Service Bulletin No: 28-002**Ref No: 44****Modification No: EC-19-0081, EC-19-0191****ATA Chapter: 28****FUEL - DISTRIBUTION****REPLACEMENT OF THE SADDLE CLAMPS AND ALIGNMENT OF THE MOTIVE-FLOW FUEL PIPES****1. Planning information****A. Effectivity**

PC-24 aircraft MSN 101 thru MSN 150.

Replacement of the saddle clamps and alignment of the motive-flow fuel pipes
Figure 1 (Sheet 1 of 3)

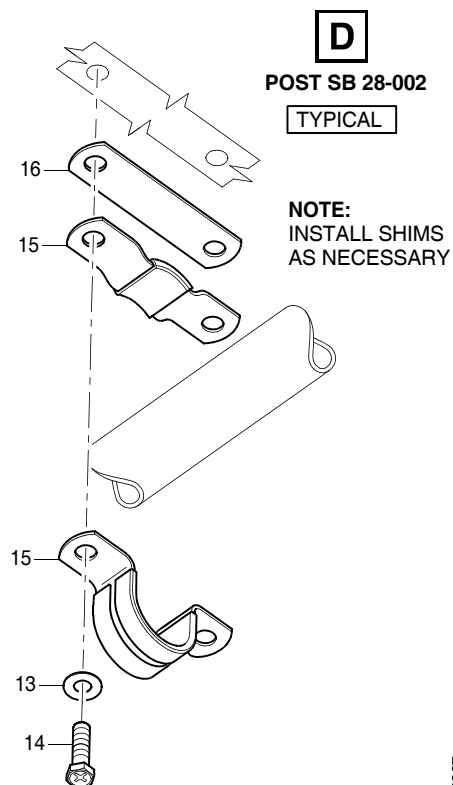
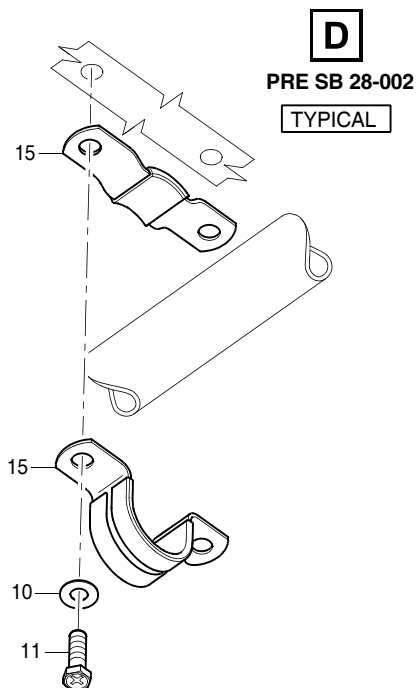
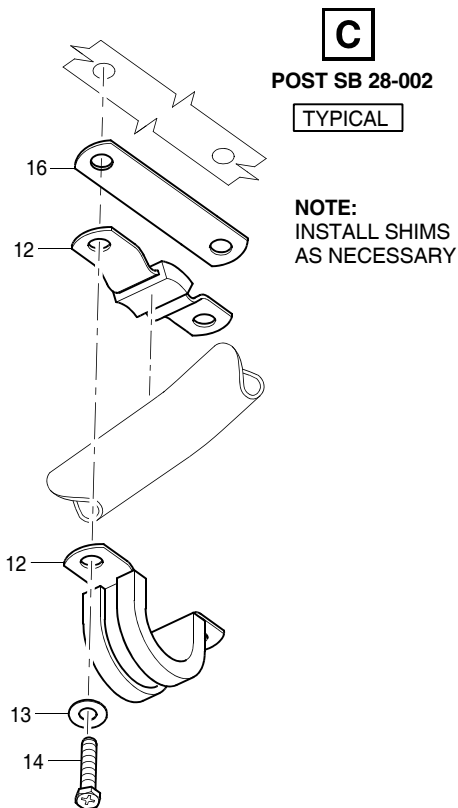
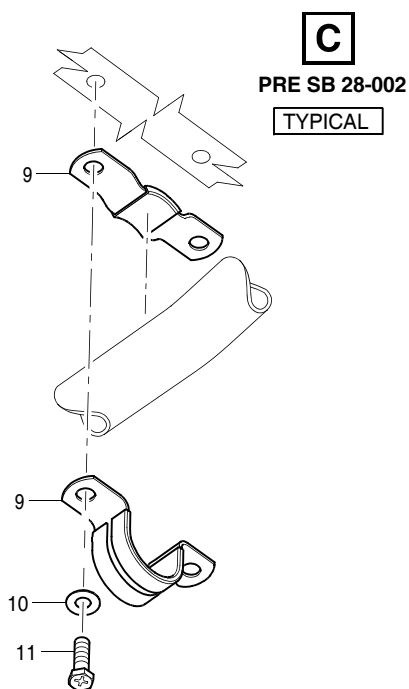
(1) Disassemble the slider shroud and coupling on the LH and RH motive-flow fuel pipe. Refer to Figure 1 (Sheet 1, View B)

- (a) Put a container below the LH and RH motive-flow fuel pipe at the slider shroud (8) and coupling (7) installation position.
- (b) Remove the slider shroud nut (1) from the slider shroud (8).
- (c) Move the slider shroud (8) onto the motive-flow fuel pipe sufficiently to get access to the two O-rings (4) that are installed on the two large ferrules (2).
- (d) Release and remove the coupling (7) from the motive-flow fuel pipe.
- (e) Move the sleeve (6) onto the motive-flow fuel pipe sufficiently to get access to the two O-rings (5) that are installed on the two small ferrules (3).
- (f) Remove and discard the:
 - Two O-rings (5) (P/N 946.91.30.015) that are installed on the two small ferrules (3)
 - Two O-rings (4) (P/N 946.91.30.218) that are installed on the two large ferrules (2).

(5) Assemble the slider shroud and coupling on the LH and RH motive-flow fuel pipe. Refer to Figure 1 (Sheet 1, View B)

- Two new O-rings (4) (P/N 946.91.30.218) on the two large ferrules (2)
- Two new O-rings (5) (P/N 946.91.30.015) on the two small ferrules (3).

- Outer surface only of the two new O-rings (3) that are installed on the two small ferrules (3)
- Outer surface only of the two new O-rings (4) that are installed on the two large ferrules (2)
- Inner surface of the sleeve (6)
- Inner surface of the slider shroud (8).

Replacement of the saddle clamps and alignment of the motive-flow fuel pipes
Figure 1 (Sheet 2 of 3)

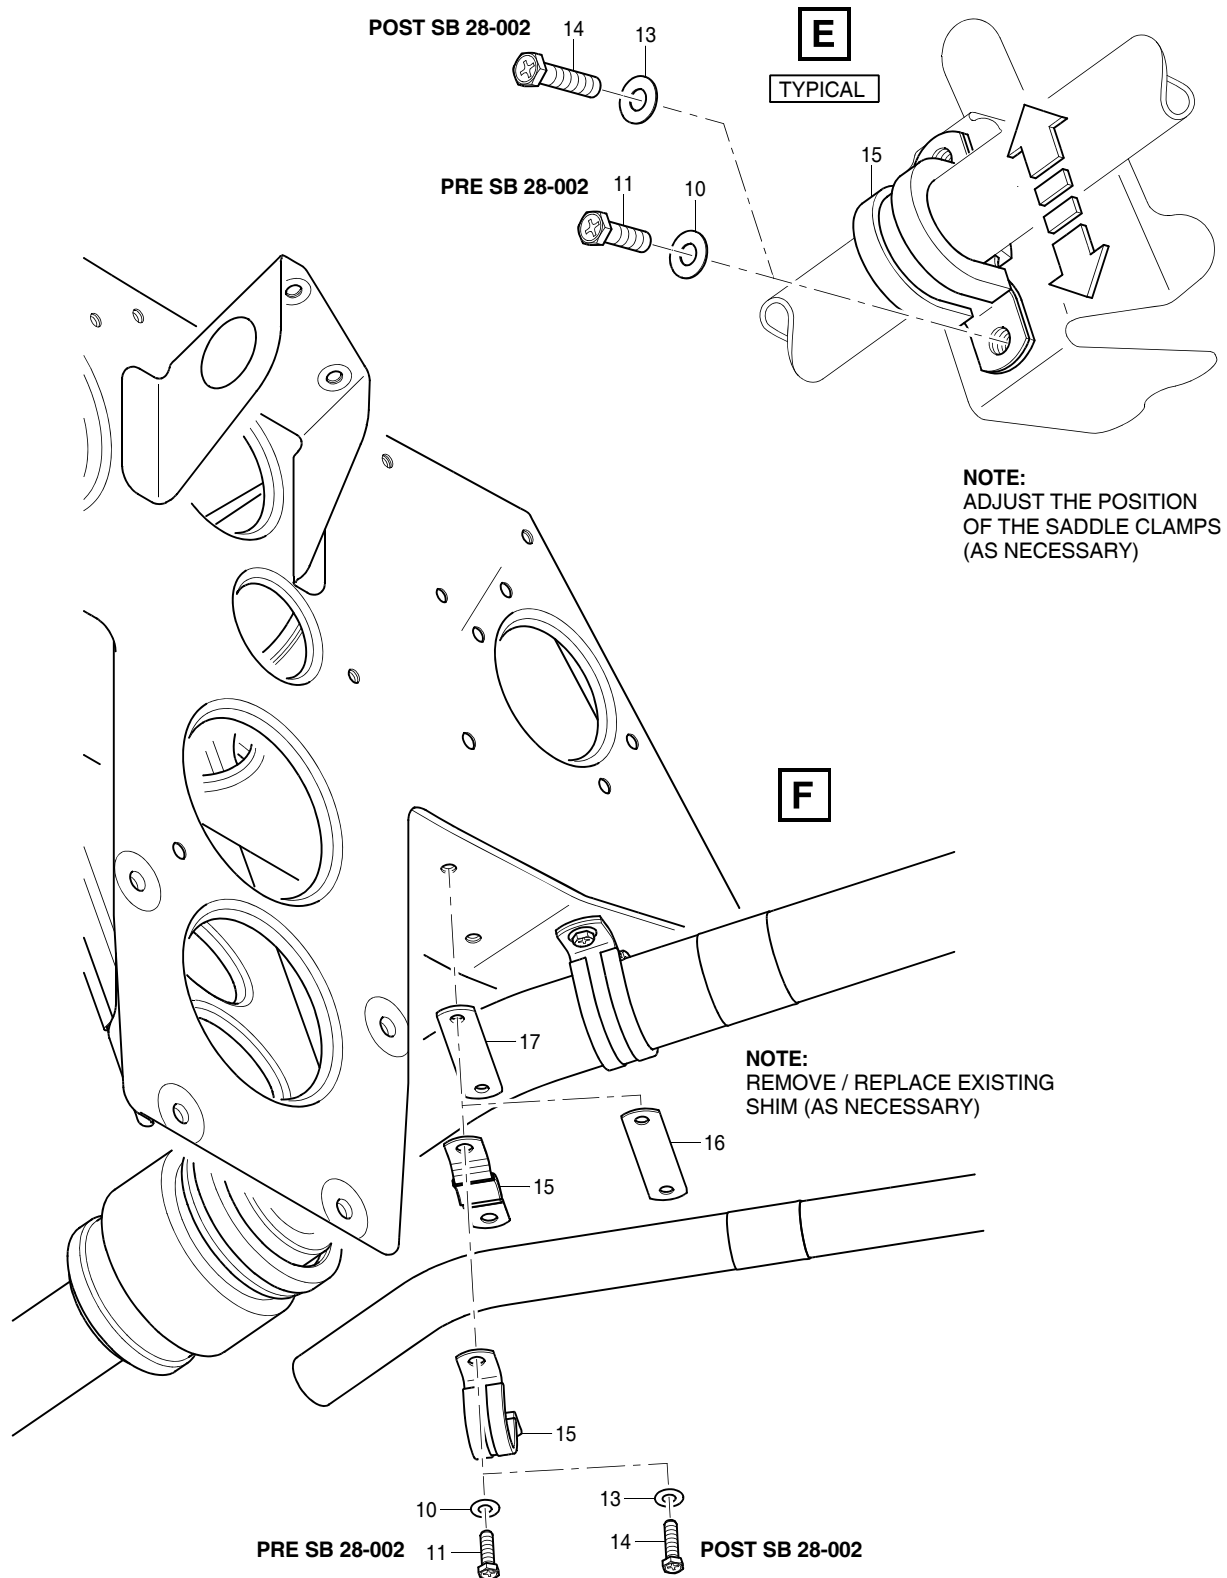
(2) Replace the saddle clamps on the LH and RH motive-flow fuel pipe. Refer to Figure 1 (Sheet 2, View C)

- (a) Hold the saddle clamp (9), remove the two screws (11) and the two washers (10).
- (b) Remove the two parts of the saddle clamp (9) from the structure and the motive-flow fuel pipe.

- Two parts of the saddle clamp (9) (P/N 946.33.22.004)
- Two screws (11) (P/N 932.35.10.067 / P/N 932.35.10.069)
- Two washers (10) (P/N 938.77.11.110).

(d) If necessary, apply a thin layer of aeroshell grease 58 (Material No. P04-041) to the threads of two new screws (14) (P/N 932.35.10.070).

(e) Put the two parts of the new saddle clamp (12) (P/N 946.33.21.933) in position on the structure and the motive-flow fuel pipe.

(f) Loosely install two new washers (13) (P/N 938.78.11.202) and the two new screws (14) (P/N 932.35.10.070).

NOTE: Due to the installation of the four new saddle clamps (P/N 946.33.21.933), the position of the LH and RH motive-flow fuel pipes has moved by approximately 0.06 in (1,5 mm). It is possible that it will be necessary to install (or remove) shims and/or adjust the position of the existing saddle clamps to correctly align the LH and RH motive-flow fuel pipes.

NOTE: This alignment procedure is very important. The permitted offset limits for the alignment of the LH and RH motive-flow fuel pipes are as follows:

- Axial offset must be between 0.12 and 0.16 in (3,00 and 4,00 mm)
- Radial offset must be a maximum of 0.02 in (0,50 mm).

Replacement of the saddle clamps and alignment of the motive-flow fuel pipes
Figure 1 (Sheet 3 of 3)

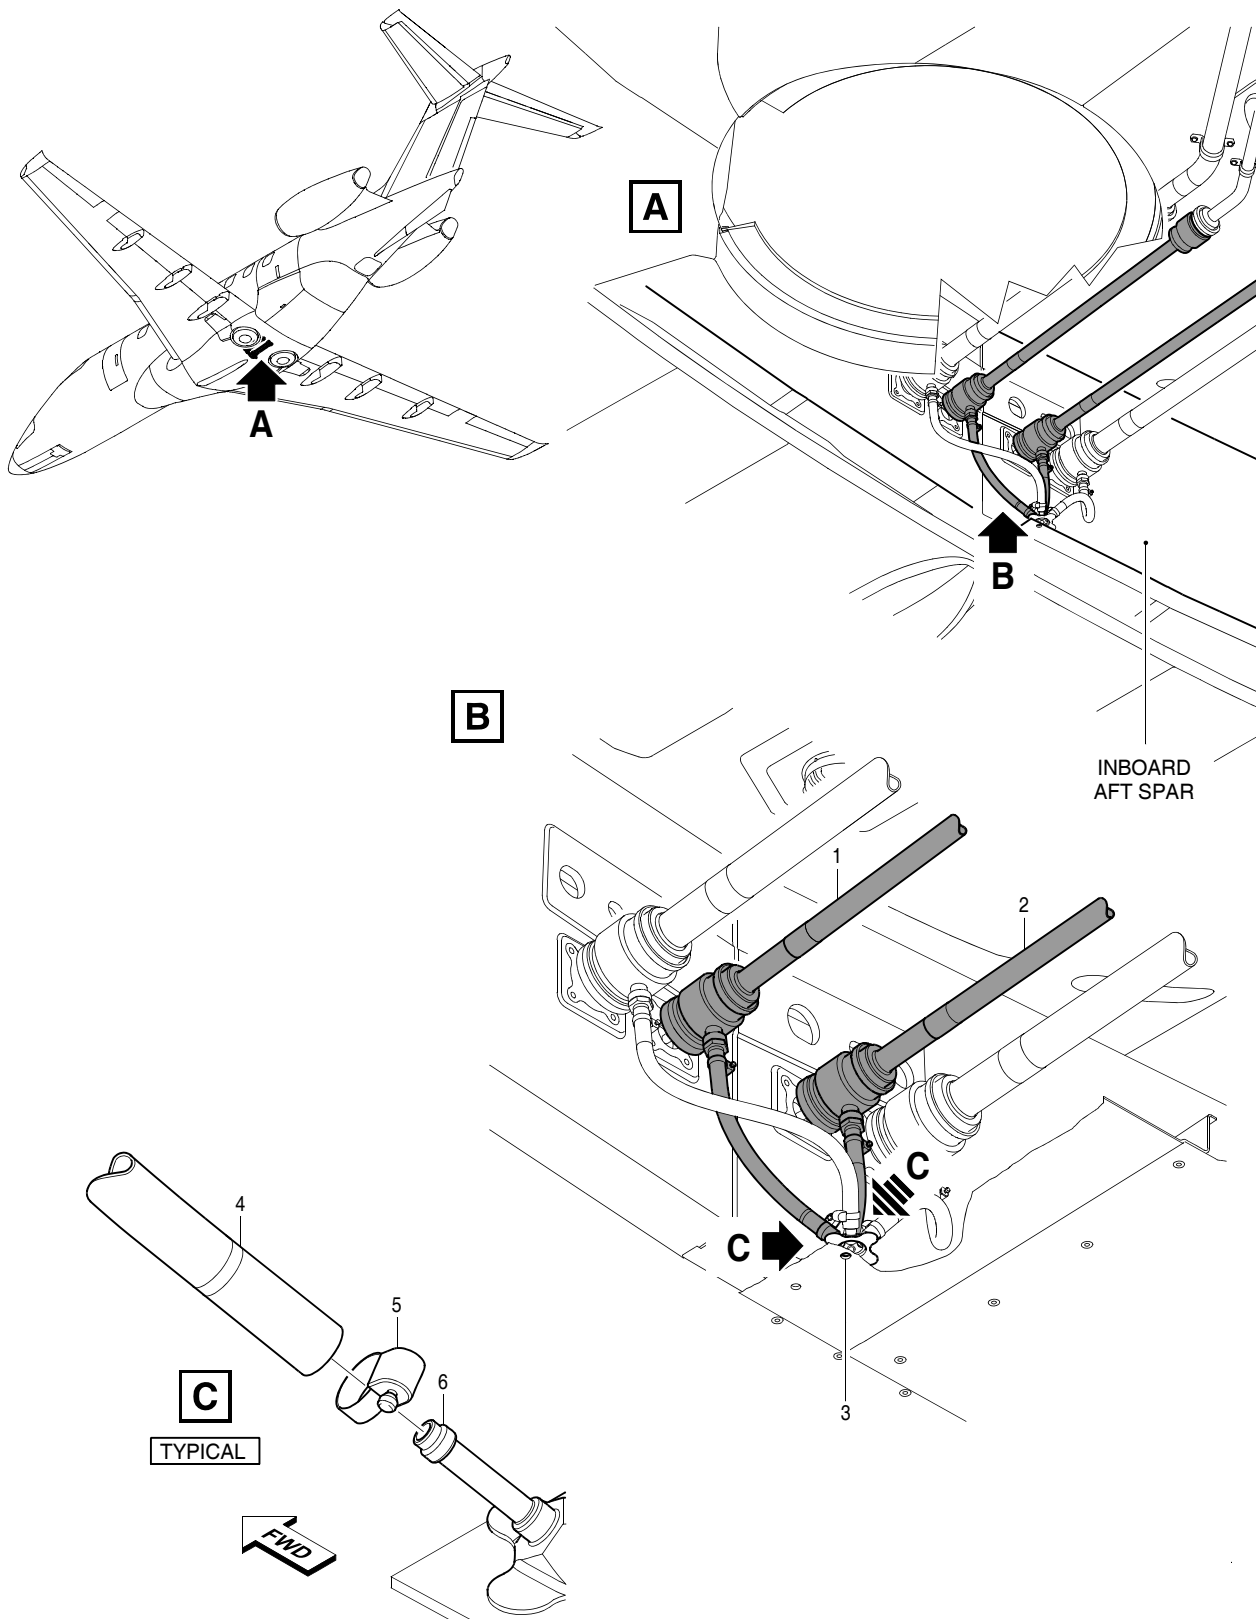
(3) Replace the screws and washers on the existing saddle clamps. Refer to Figure 1 (Sheet 2 and 3, View D, E and F)

NOTE: The saddle clamp shown in View F already has a shim installed. It is possible that it will be necessary to remove or replace this shim.

- Install shims (16) at the saddle clamps (12) as shown in View C
- Adjust the position of the saddle clamps (15) as shown in View E
- Remove or replace the shim (17) as shown in View F.

9 If necessary, to adjust the position of the saddle clamps (15) as shown in View E:

ii Move the saddle clamp (15) up or down (as necessary) to correctly align the RH motive-flow fuel pipe. If necessary, adjust the position of the bracket that the saddle clamp is attached to.

- 10 If necessary, to remove or replace the shim (17) as shown in View F:
- i Hold the saddle clamp (15), remove the two screws (14) and the two washers (13).

- NOTE:** If necessary, a maximum of two shims can be installed below the saddle clamp.
- ii Remove the existing shim (17) or replace the existing shim (17) with one or two new shims (16) (P/N 528.22.24.105), as necessary, below the saddle clamp (15).
